SUBJECT: COMANCHE PEAK NUCLEAR POWER PLANT, UNITS 3 AND 4
DOCKET NUMBERS 52-034 AND 52-035
RESPONSE TO REQUEST FOR ADDITIONAL INFORMATION NO. 4957, 5027,
AND 5052

Response to Request for Additional Information No. 4957 (CP RAI #178)

Response to Request for Additional Information No. 5027 (CP RAI #177)

Response to Request for Additional Information No. 5052 (CP RAI #179)

Figure 1. Map of Quaternary geology, geologic field reconnaissance, and aerial photograph coverage of the site area and beyond.

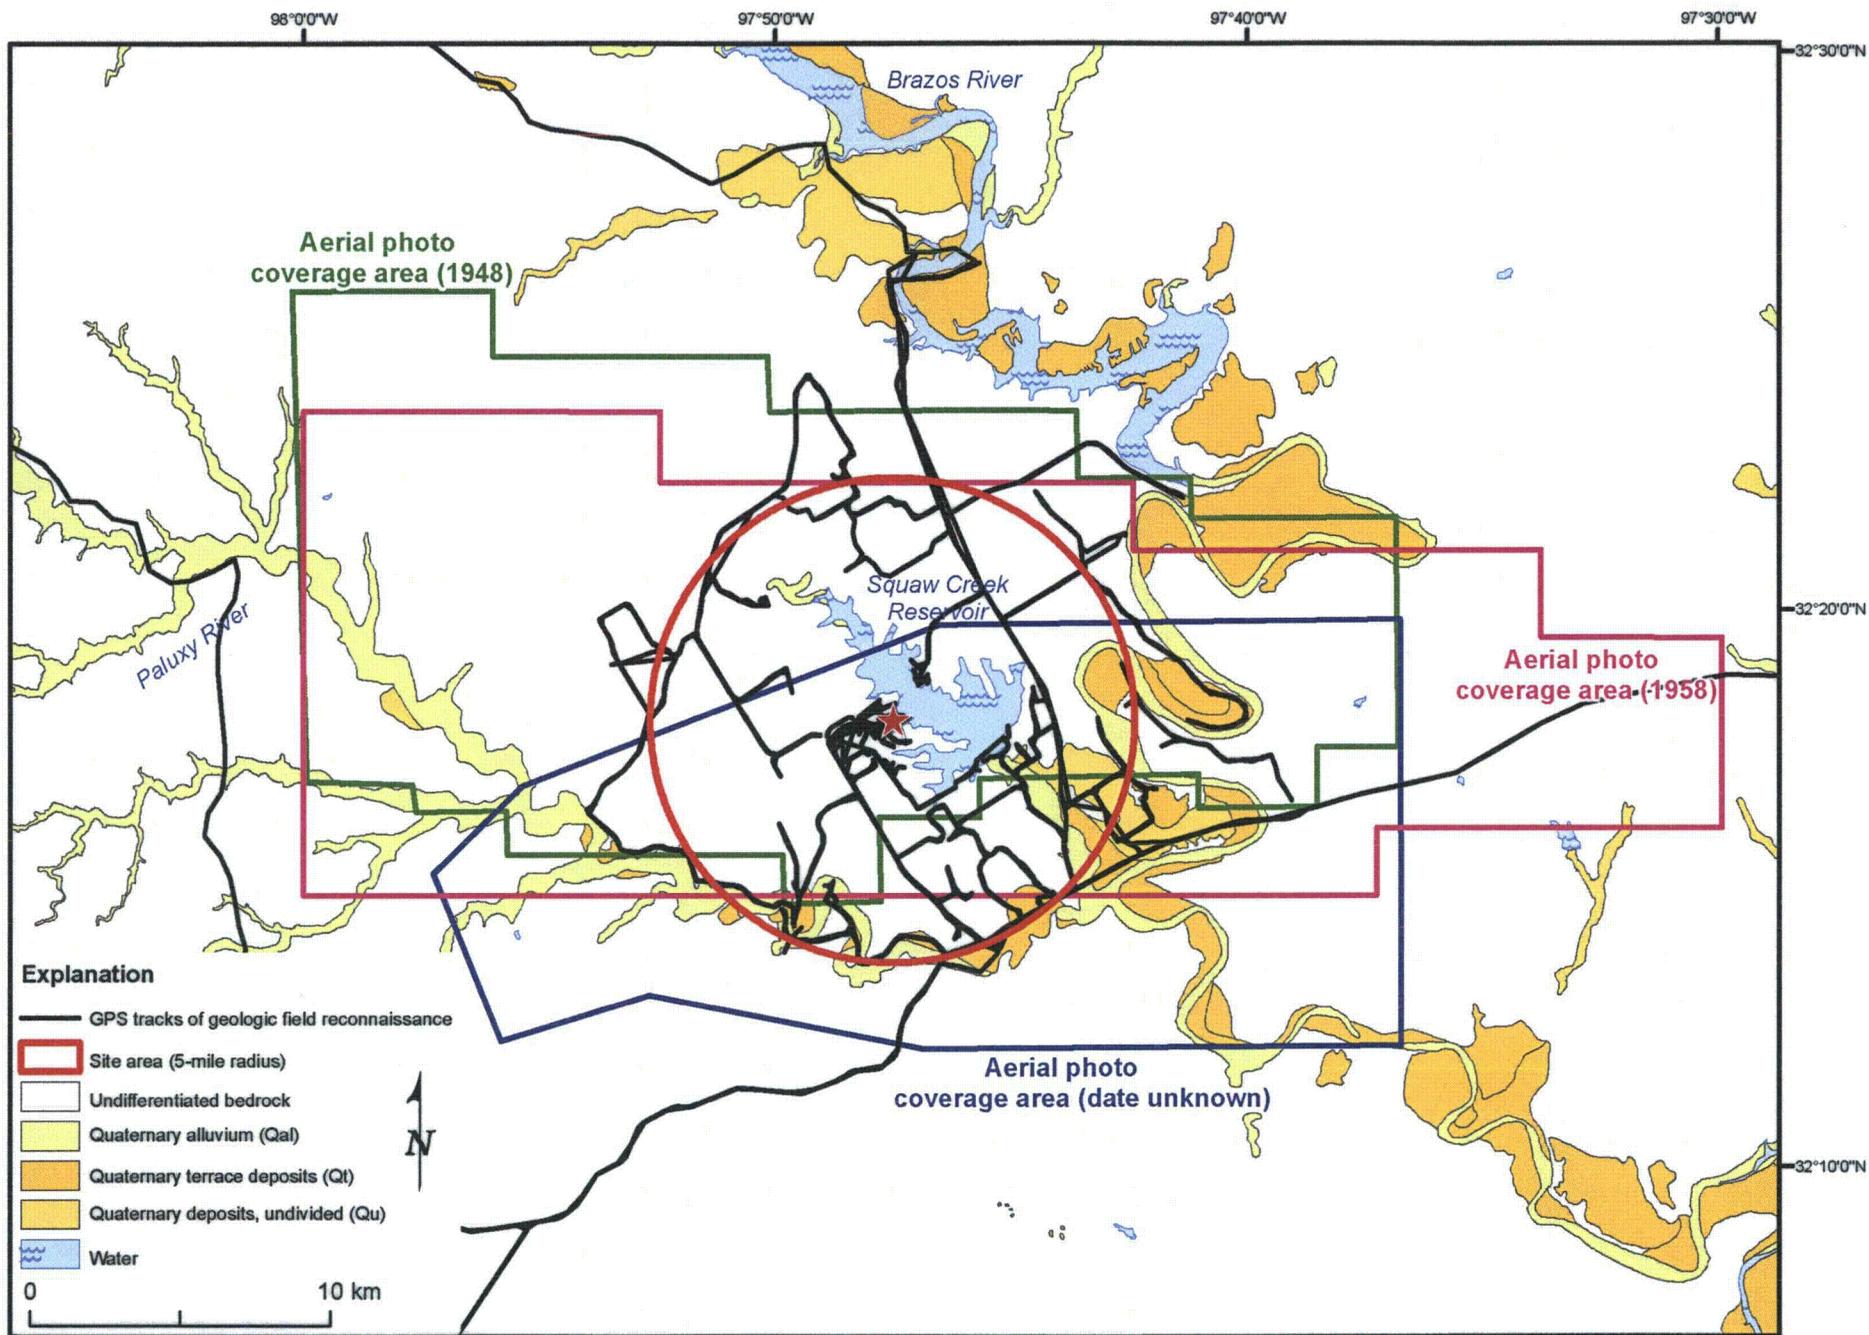
The staff reviewed the WLA "Field Reconnaissance Report" that you provided to the NRC (ADAMS Number ML092290416) but found no specific mention of localities targeted to investigate paleoliquefaction features in Quaternary alluvial deposits. The staff also reviewed the GPS track log of areas covered during the field investigations, but found it difficult to identify locations specifically targeted to investigate liquefaction features because those locations were not identified in the field logs.

Please provide more detailed documentation of the locations investigated to specifically search for paleoliquefaction features or deformation in Quaternary alluvial deposits. Did you specifically search for locations, where outcrops of these deposits might exist? In addition, please explain if any follow up investigations were conducted to further investigate the presence or absence of such features.

(a) Did you re-investigate aerial photographs for signs of sand blows or fissures, separate from the lineament analysis? If not, why? (b) Did you re-investigate Quaternary alluvial surfaces when water levels and vegetative growth were at a minimum? If not, why?

The field reconnaissance records in the WLA "Field Reconnaissance Report" (ML092290416) do not specify any locations targeted for liquefaction inspection because no locations were identified from the initial evaluation of the aerial photography. As shown on the track log plots on Figure 1, the Quaternary deposits were visited where public access was available. No evidence for seismically-induced liquefaction was noted during geologic field reconnaissance. However, it was noted that much of the Quaternary surfaces are highly vegetated and exposures are limited. No follow-up investigations were conducted after the two site area reconnaissance visits.

(a) Aerial photographs were re-investigated to search for signs of sand blows and fissures. Figure 1 shows the coverage area of aerial photographs evaluated. As shown in the table below, these photographs are black-and-white images acquired by the U.S. Geological Survey (USGS) and Texas Natural Resources Information Services (TNRIS) between 1942 and 1958, predating construction activities at the site. These photographs include both stereo-paired and oblique imagery. A few of these photographs show semi-circular areas of light-colored surface material that could be interpreted as possible evidence for surficial sand-blow deposits. However, these features are located in areas of active cultivation as well as Glen Rose Formation outcroppings where the material is not susceptible to liquefaction (limestone and shale) and the water table is deep. Taken together, the results from geologic field reconnaissance and evaluation of aerial photographs indicate the absence of seismically-induced liquefaction features within the site area and beyond.

- (b) The Quaternary surfaces in the site area as shown on Figure 1 were not re-investigated due to observations made during the initial geologic field reconnaissance investigations and aerial photography review, neither of which provided evidence for seismically-induced liquefaction. Further, the sparse historical seismicity of the region does not indicate a strong potential for the existence of seismically-induced liquefaction features within the site area.
